Re: Memorandum in Response to the Auckland Council Ecology Pre-App Meeting on 25/11/2025

This memorandum responds to item 6 in the meeting minutes prepared by Barker and Associates, addressing matters raised by [REDACTED], Auckland Council's terrestrial ecology specialist, concerning public walkways, offsets, and additional planting within the existing Stage 2 consent notice area.

Figure 2 - Additional areas for planting around the Stage 2 consent notice area

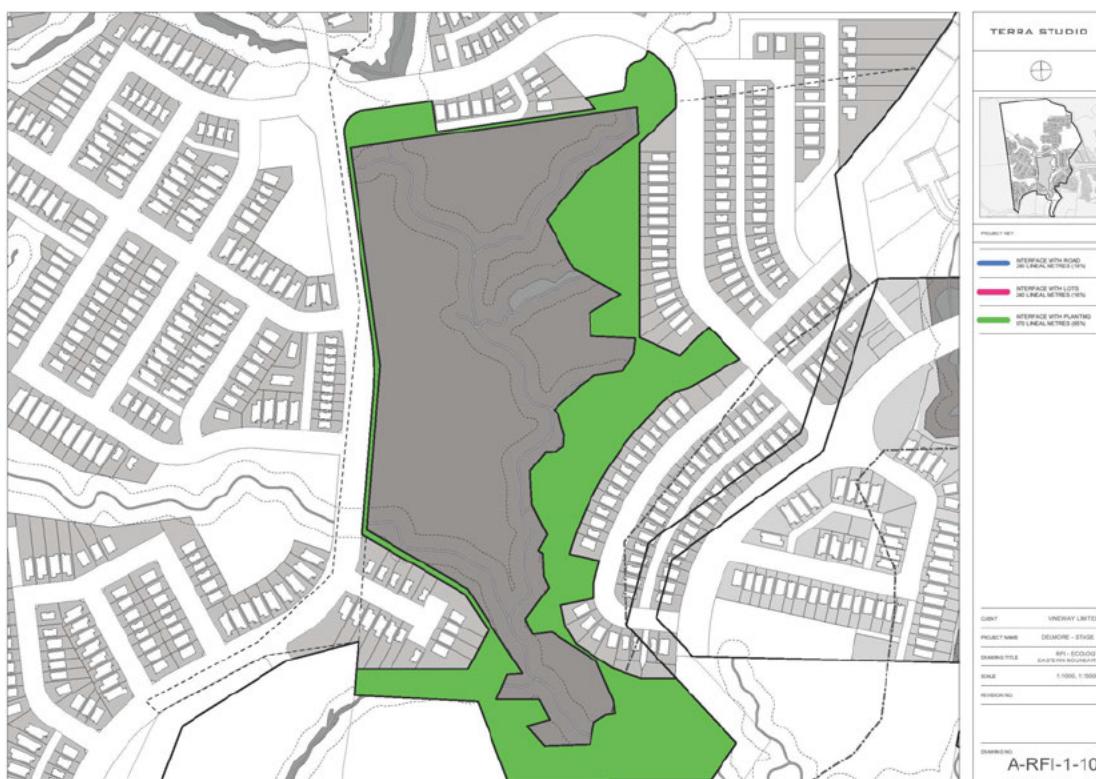
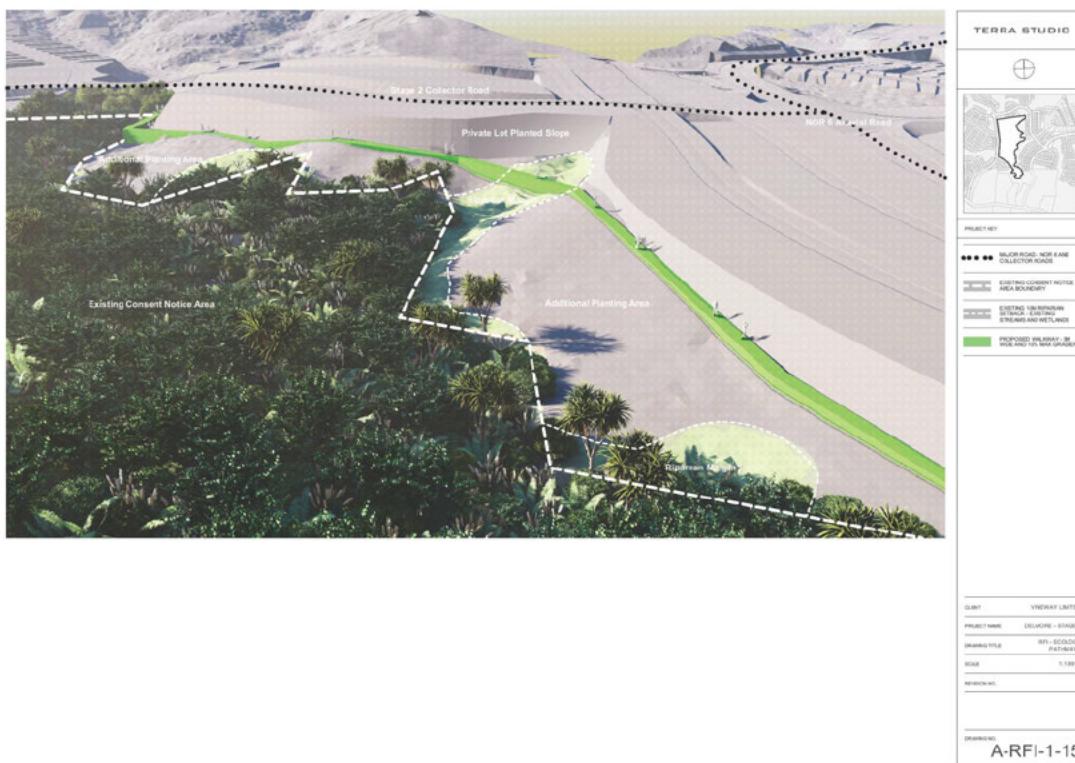
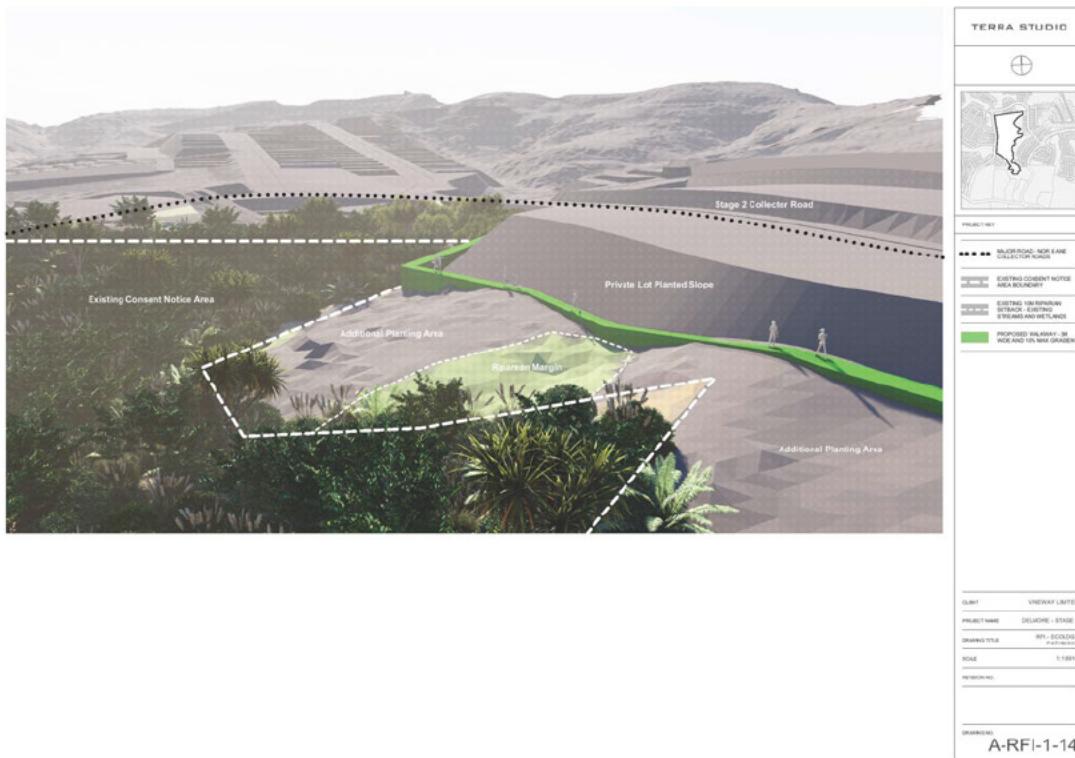
The existing steep topography in Stage 2A-1 requires the proposed residential lots to the east of the consent notice area to be set back using planted batter slopes. In response to recommendations from [REDACTED], the applicant has proposed a public pedestrian walkway along the base of the private batter slopes to ensure passive surveillance of the protected vegetation while providing additional amenity for the residents. The proposed walkway achieves maximum gradients of 10% and includes small bridge structures where stream crossings are required. The walkway connects the northern portion of the Stage 2 collector road / Road 05 to the paper road and future NOR 6 extension.

There are 46 houses located along the eastern consent notice area boundary that all achieve a 10m setback from the house to the consent notice area. Additionally, 40 of the 46 houses achieved 20m setbacks (87%), 27 of the 46 houses achieve 30m setbacks (59%) and 20 of the 46 houses achieve 40m.
